POUDRE SCHOOL DISTRICT R-1
NEW FORT COLLINS HIGH SCHOOL
FORT COLLINS COLORADO

FIRST FLOOR PLAN
ADMINISTRATION
DINING & COMMONS

FIRST FLOOR PLAN
SERVICE WING
LOADING DOCK
1/8"

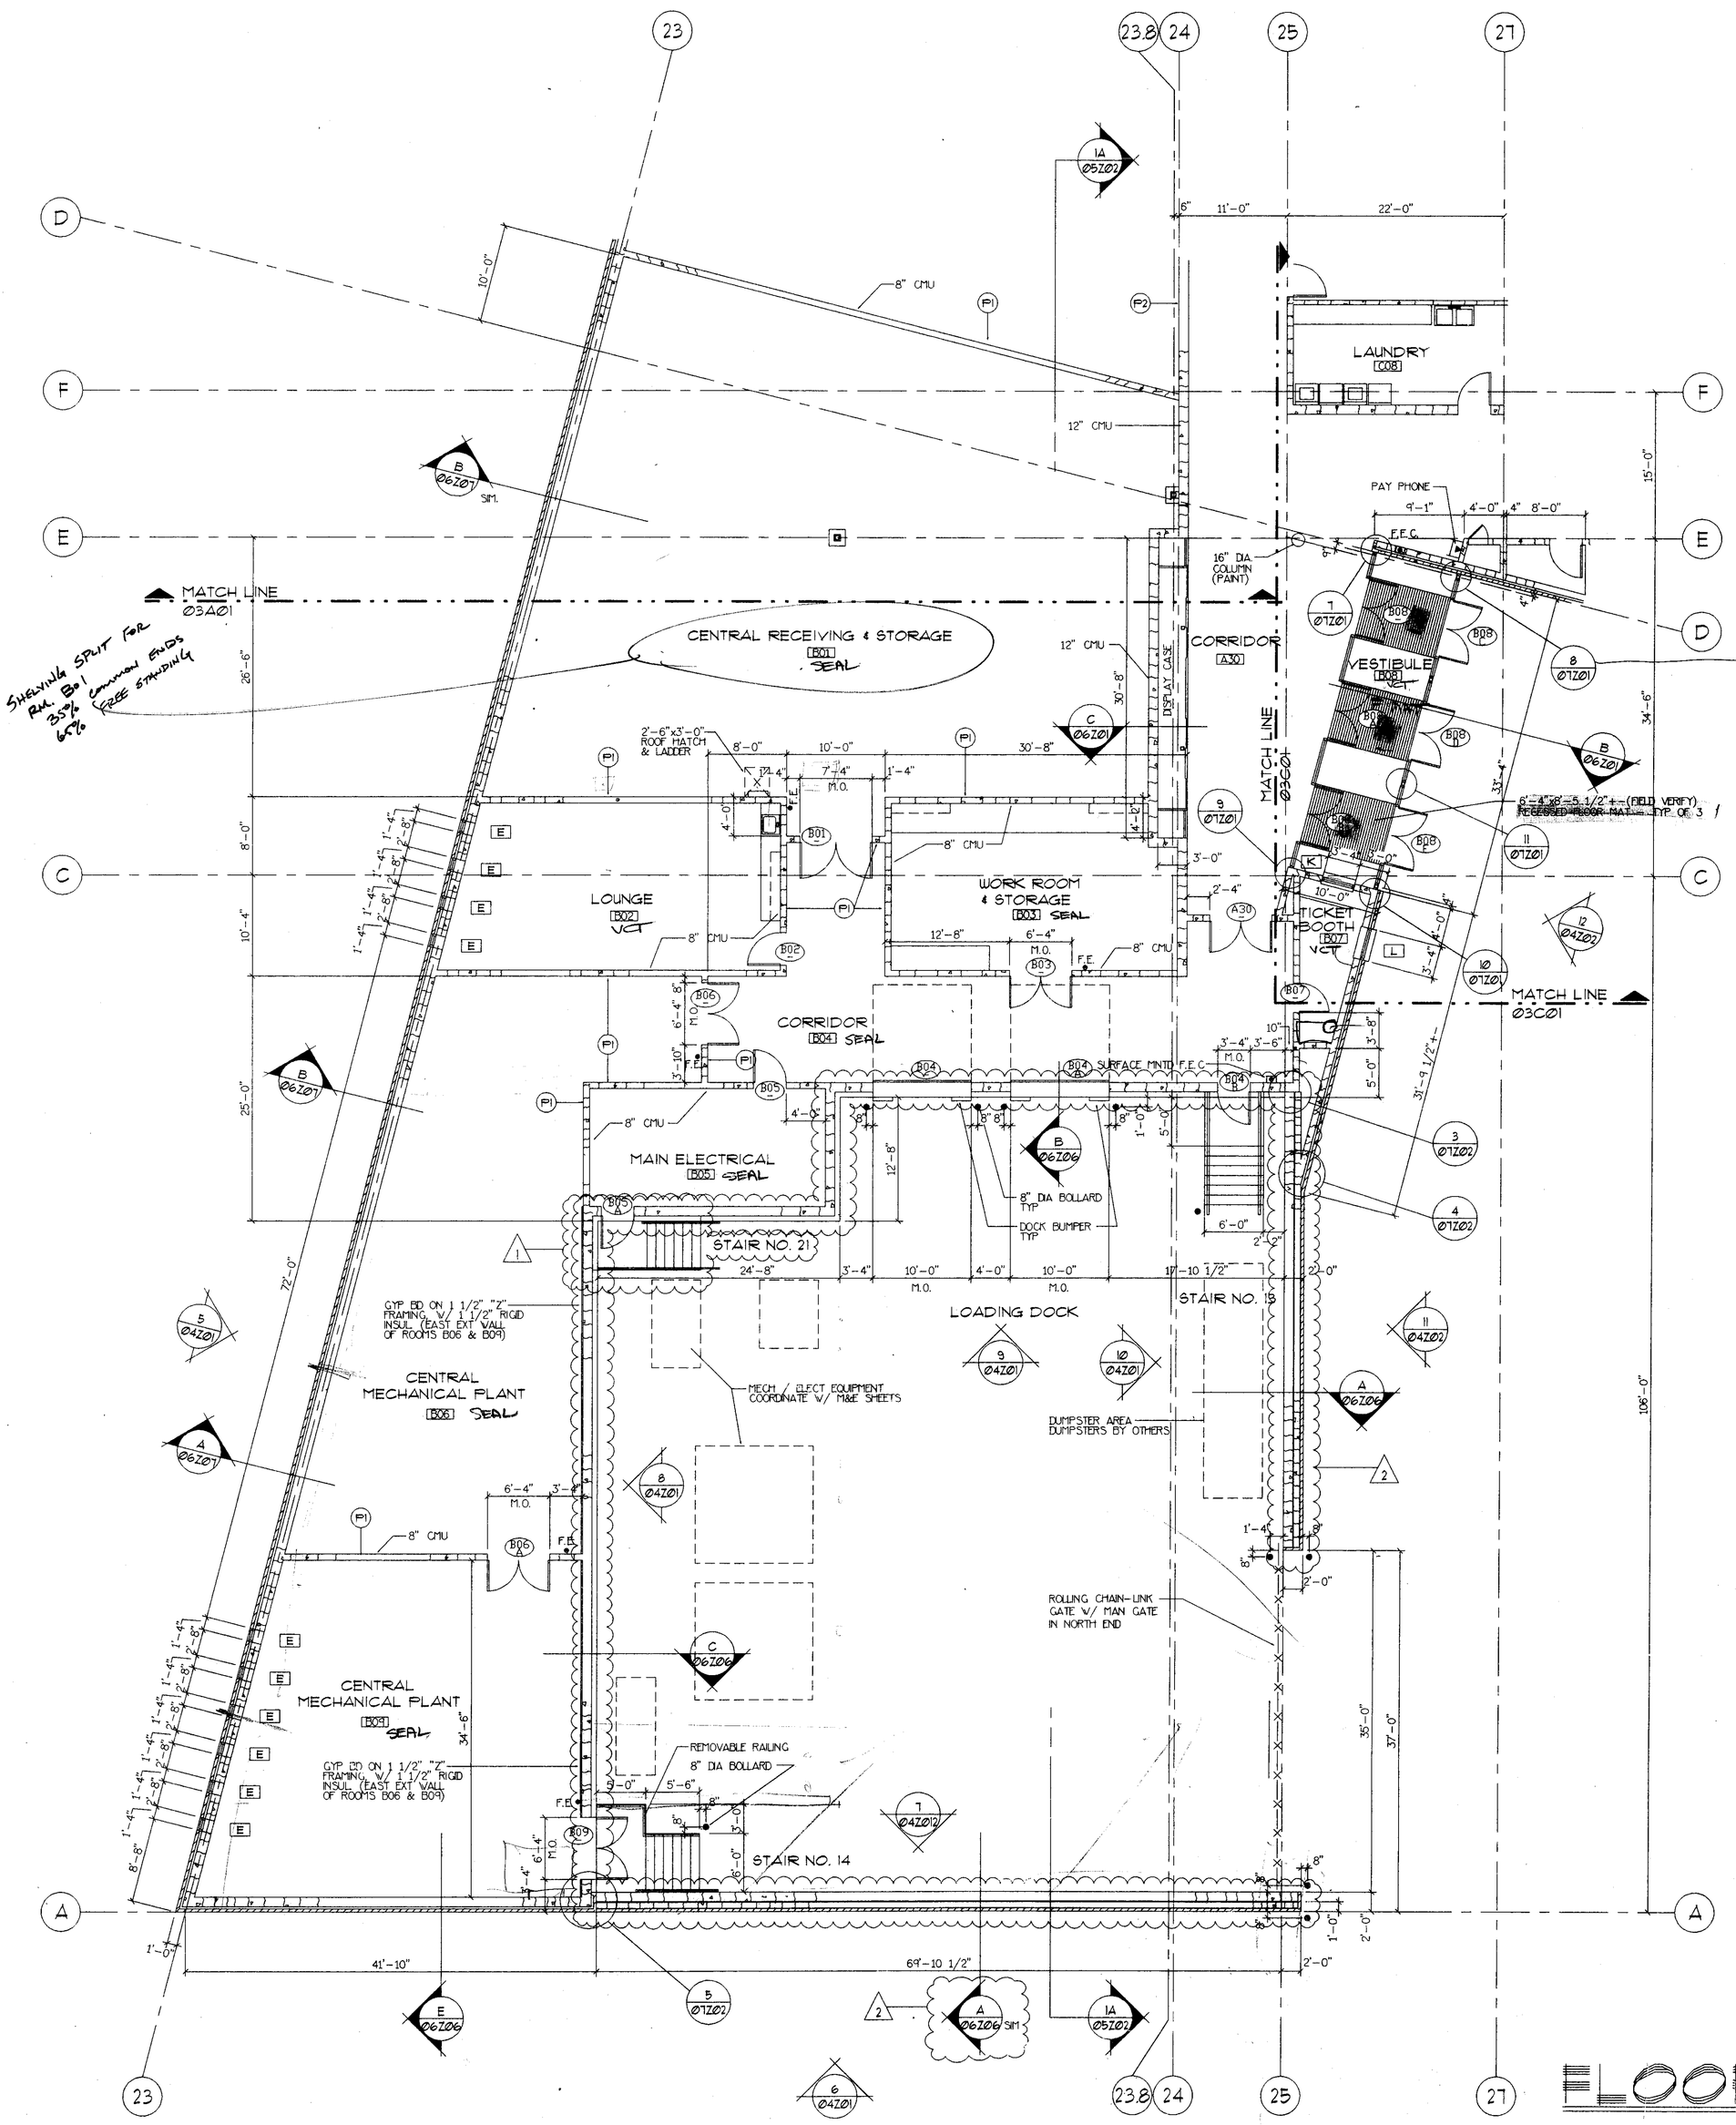
01/20/94: Relocate ladder to South wall of B09 as proposed. Coordinate interface with other trades. Modify ladder as required. PS.

SEE RFI # 236

FIRST FLOOR PLAN
AUXILIARY GYM
P.E. CLASSROOM
STAFF LOCKER / OFFICES

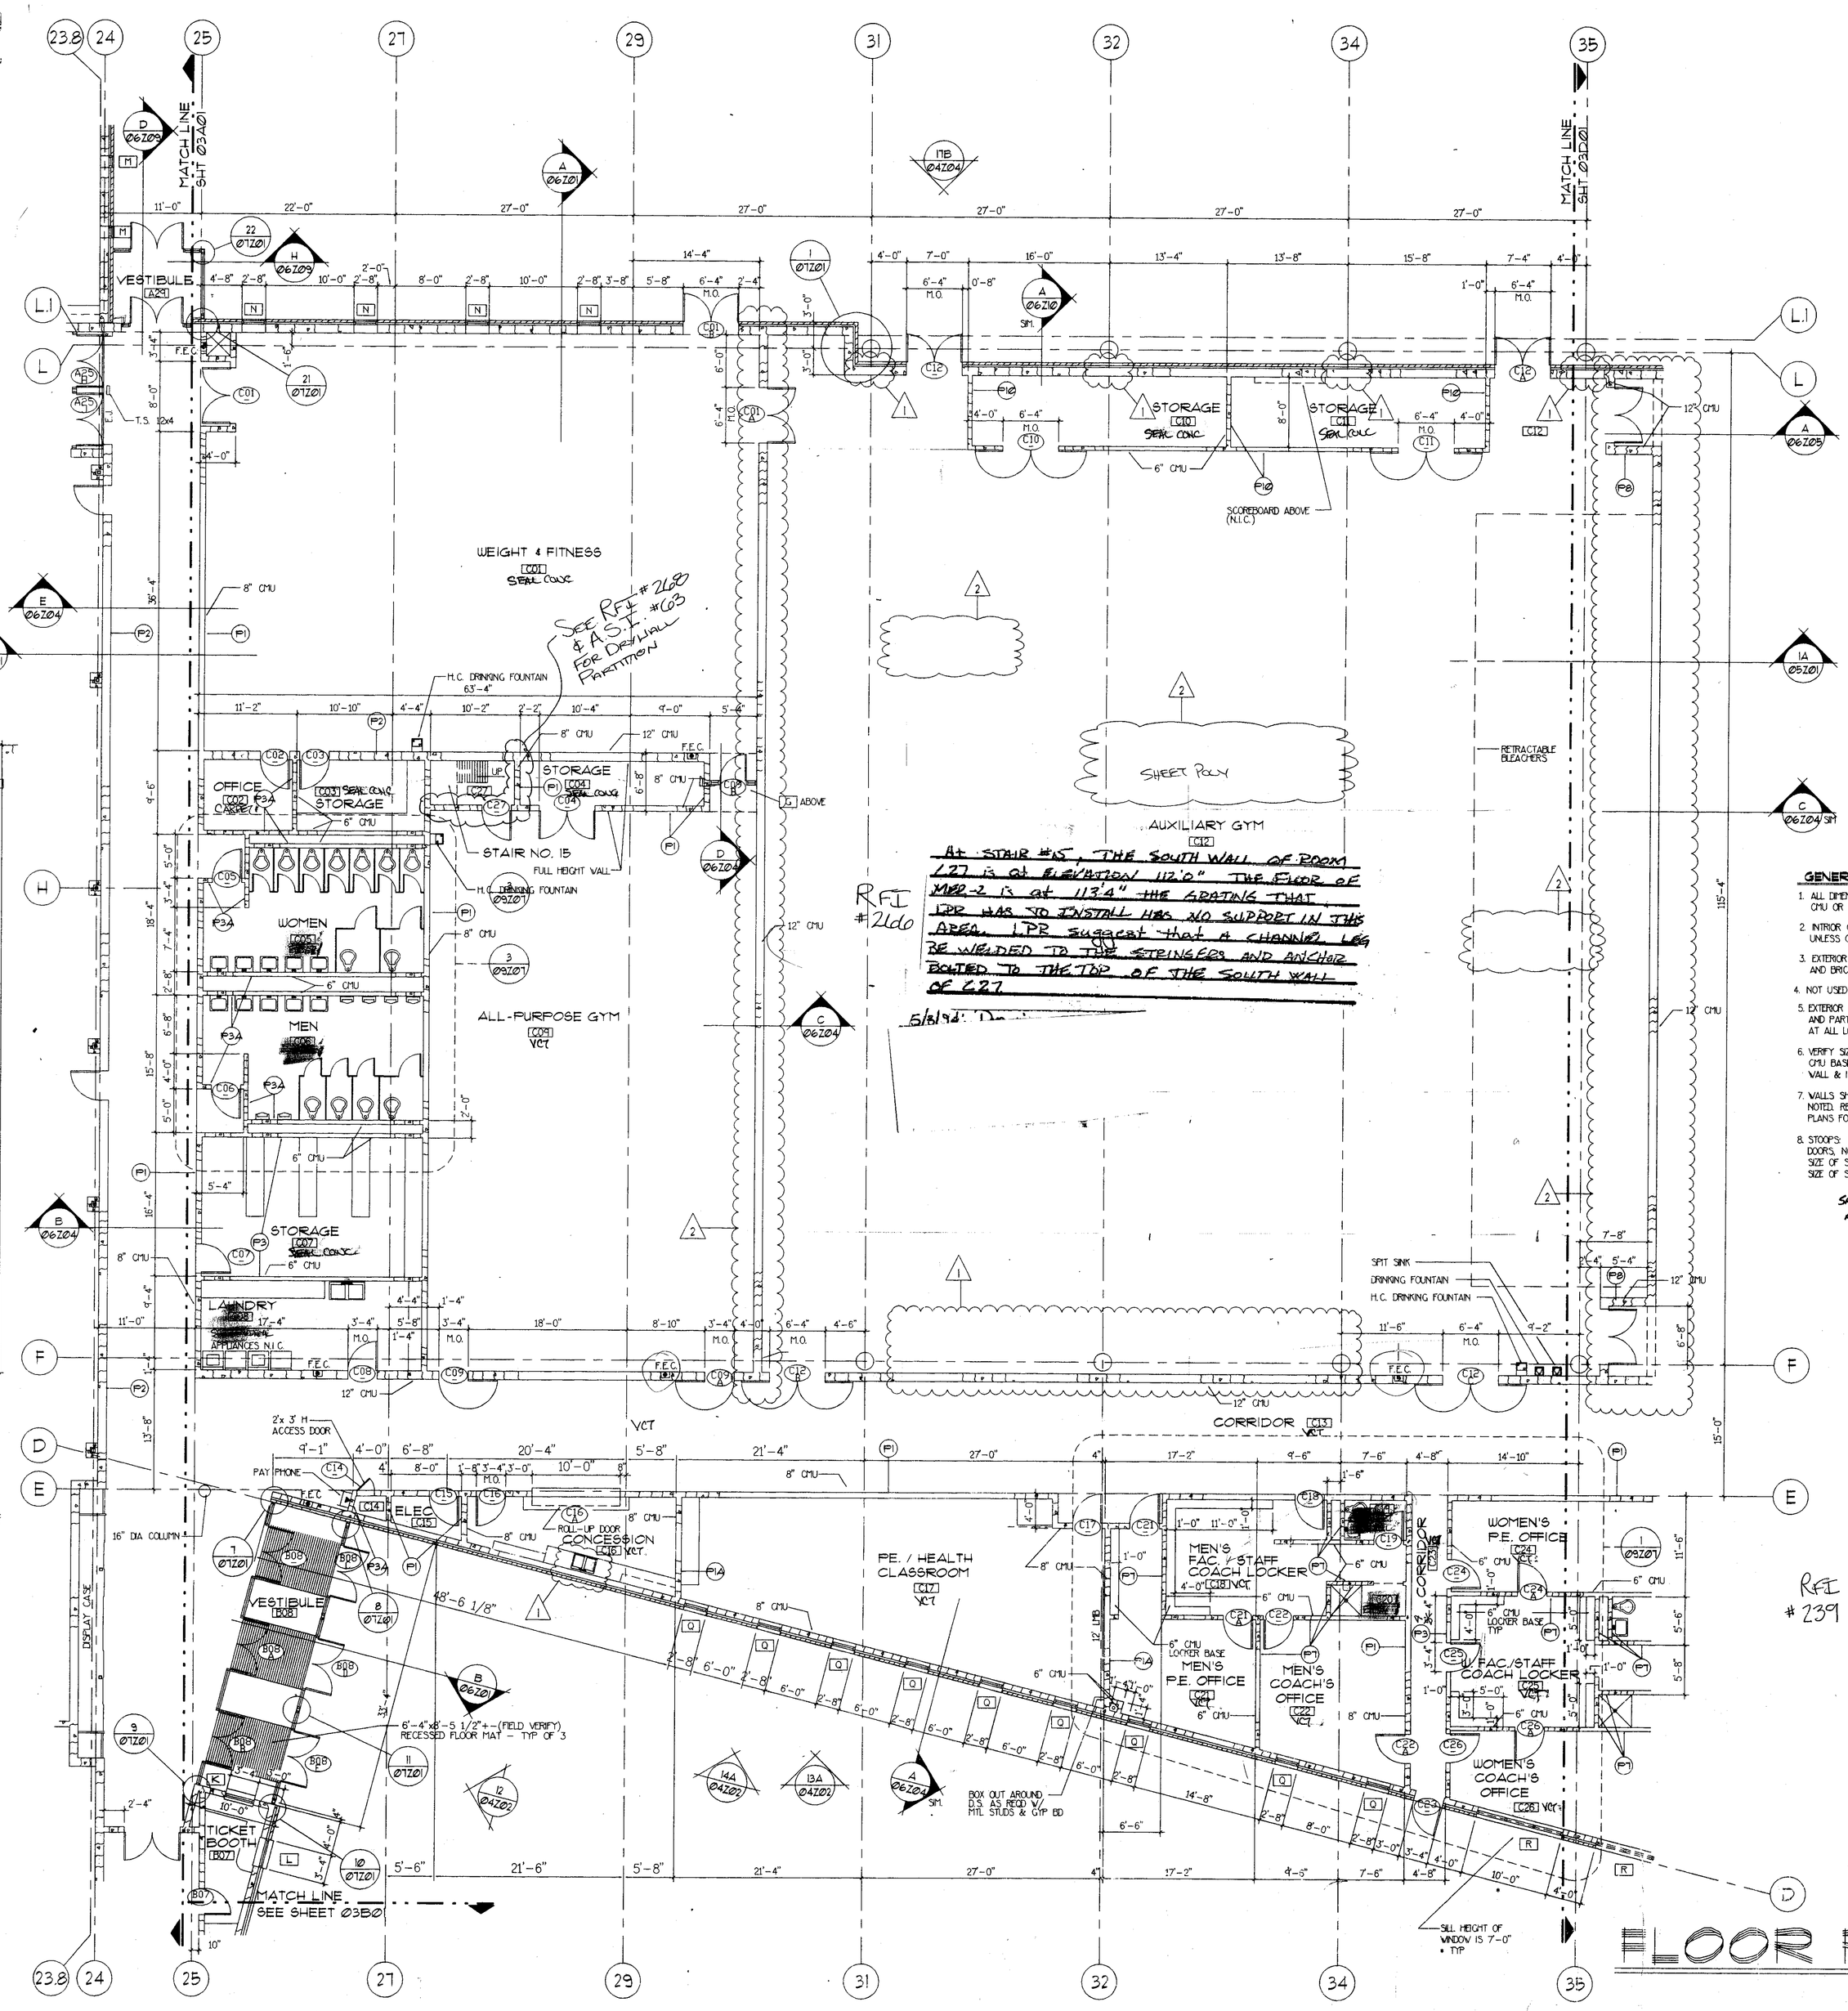
At stair #15, the south wall of room C27 is at elevation 112'-0". The floor of MBR-2 is at 113'-4". The grating that IPR has to install has no support in this area. IPR suggest that a channel leg be welded to the stringers and anchor bolted to the top of the south wall of C27.

RFI #239

4/28/94: Door C23 was changed to H.M. in contract discussions w/ Metropolitan. It appears it did not get added to H.M. Doors and frames.

Door C23 and frame. Labor is to be H.M.

"E" WING
LOWER LEVEL FLOOR PLAN

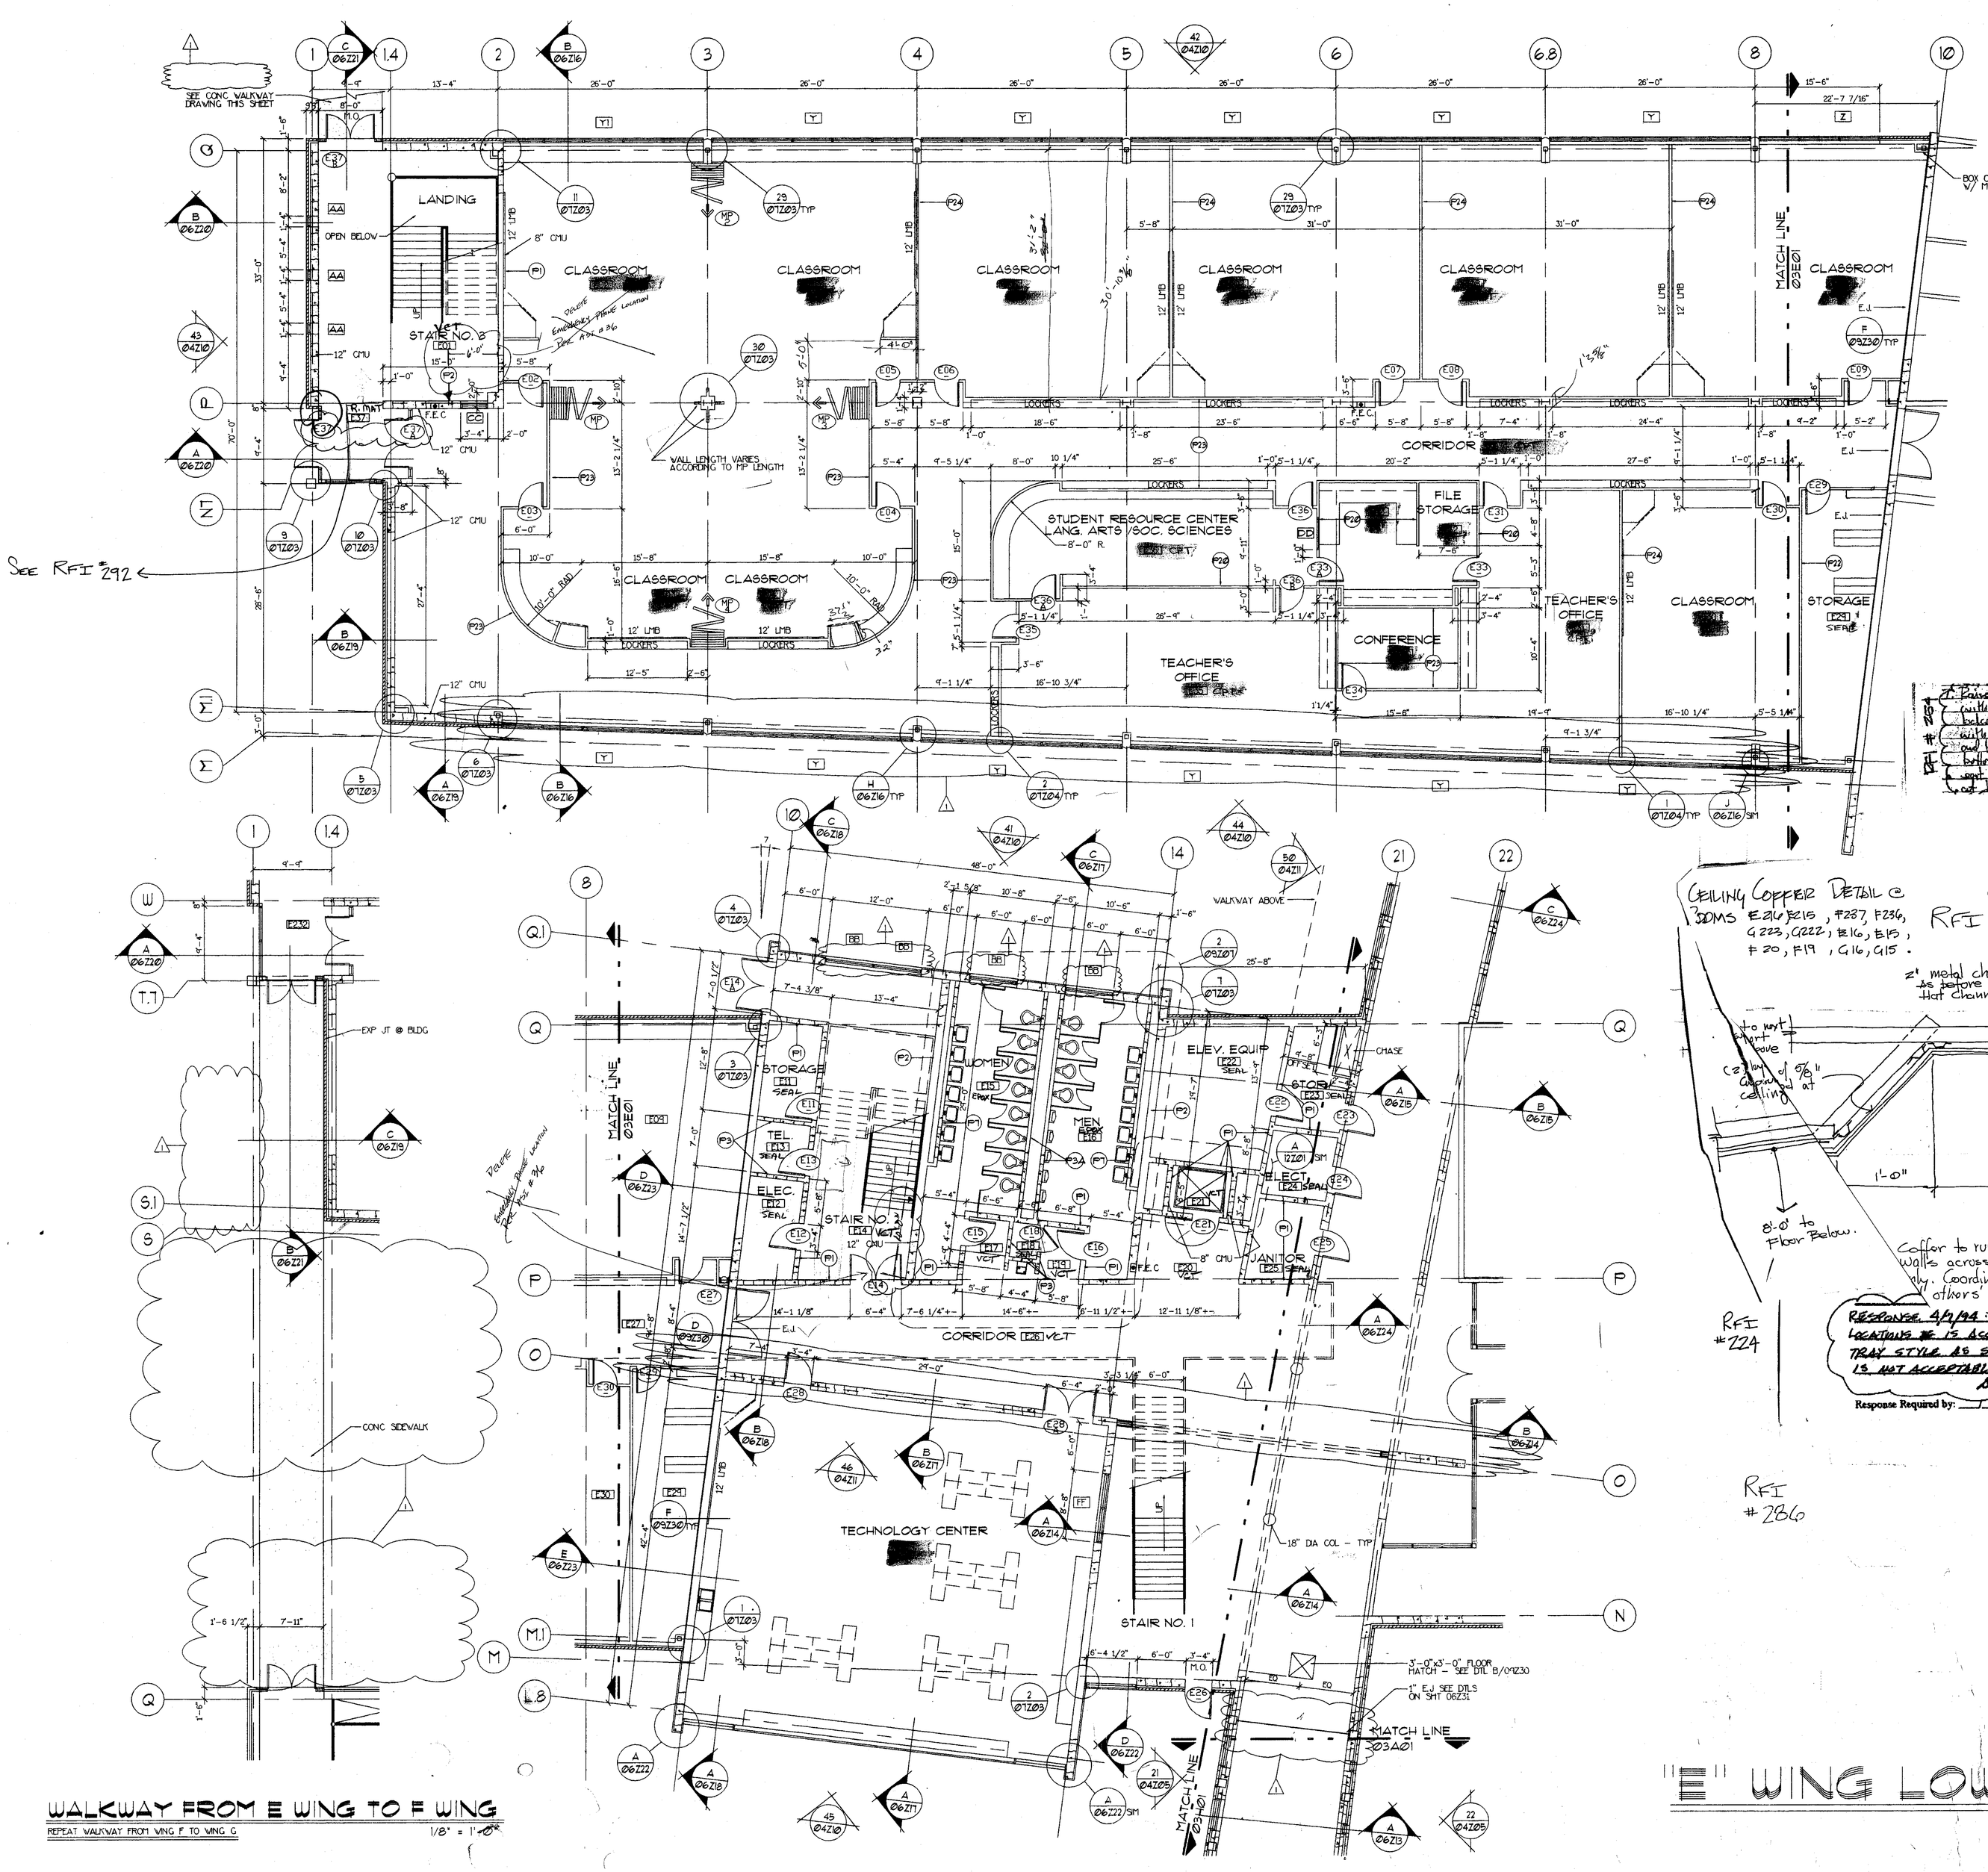
SHELVING FOR RM NO. E29 IS 100% COMMON BLDG PER RFI NO. 180

RFI #284

Raise the ceiling at under mech stairs at soffit to line of ceiling N/S Room immediately west that will between upper hallway corridor and north wall of tech center. Remove this beam with 1/2" hole on long wall bottom of Rm flange (2) each top and bottom connections and let remained vertical between top and bottom flange at 16" O.C. Corp. Beam w/ 1/2" Lag Bolt. Add a new second beam as far west as possible to provide valid space and let valid stairway to be free & with tech center wall.
